**City of Ketchum
Planning & Building**

IN RE:)	
)	
Miller Residence)	KETCHUM PLANNING & ZONING COMMISSION
Design Review)	FINDINGS OF FACT, CONCLUSIONS OF LAW, AND
Date: August 8, 2023)	DECISION
)	
File Number: 22-046)

PROJECT: Miller Residence

APPLICATION TYPE: Mountain Overlay Design Review

C1.0

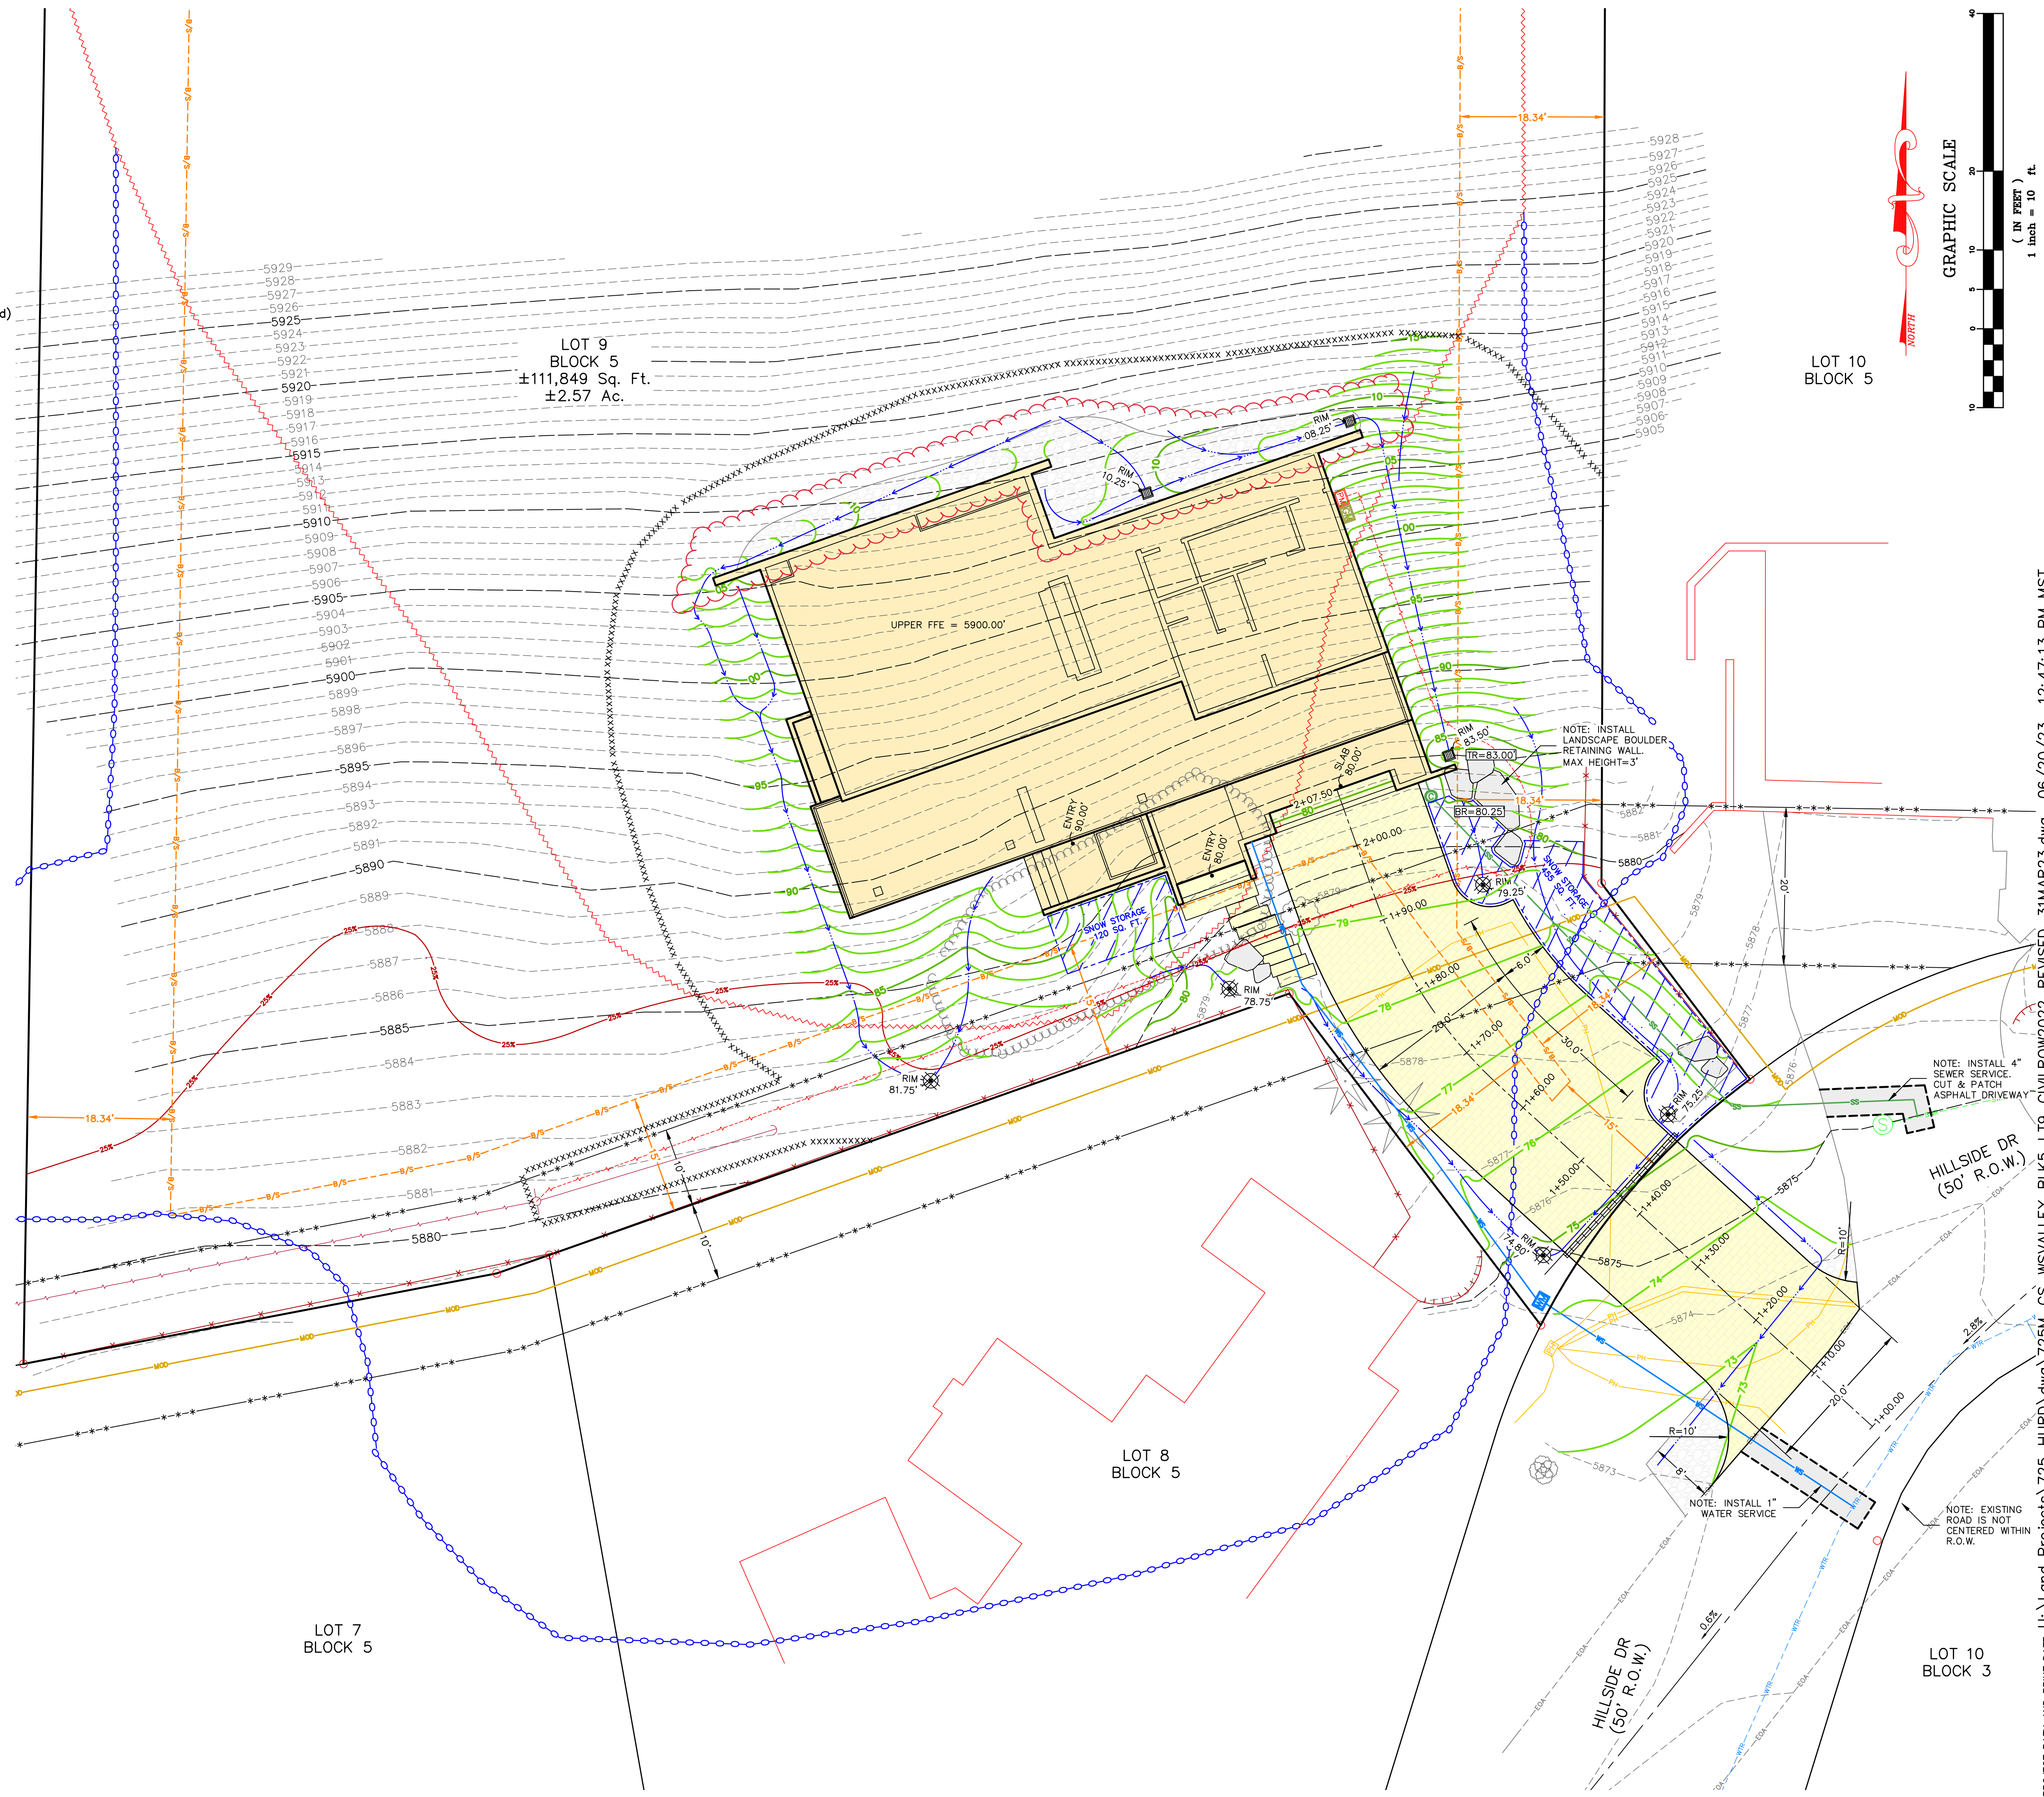
17.96.060.C.1 - Drainage	Conformance
<p><i>All stormwater shall be retained on site.</i></p>	YES
<p>Finding: Pursuant to KMC §17.96.060.C.1, all storm water drainage shall be retained on site. Drainage improvements are specified on Sheet C1.0 of the project plans. The drainage improvements include the installation of a trench drain bordering the length of the driveway. A combination of drywells and catch basins will be installed to collect stormwater from the rest of the property. The City Engineer has reviewed the proposed drainage plan and believes the trench drain and drywell improvements are sufficient to maintain all storm water drainage on-site. All drainage plans and specifications shall be reviewed and approved by the City Engineer and Streets Department prior to issuance of a Building Permit for the project.</p>

17.96.060.D.2 - Utilities	Conformance
<i>Utilities shall be located underground and utility, power, and communication lines within the development site shall be concealed from public view.</i>	YES
<p>Finding: As shown on Sheet C1.0 of the project plans, the applicant has proposed connecting to the municipal water and sewer systems from existing lines on Hillside Drive. Requirements and specification for the water and sewer connections will be verified, reviewed, and approved by the Utilities Department prior to issuance of a Building Permit for the project.</p>

17.96.060.H.2 – Snow Storage	Conformance
<i>Snow storage areas shall be provided on site.</i>	YES
Finding: Sheet C1.0 shows the snow storage areas to be provided are on-site.

17.96.060.H.3 – Snow Storage	Conformance
<i>A designated snow storage area shall not have any dimension less than five feet and shall be a minimum of 25 square feet.</i>	YES
Finding: Sheet C1.0 of the project plans indicate that no snow storage area has dimensions less than five feet.

Findings	As shown on C1.0 of the project plans, the applicant is proposing to connect to the municipal water and sewer systems from existing lines within Hillside Drive. Requirements and specification for the water and sewer connections will be
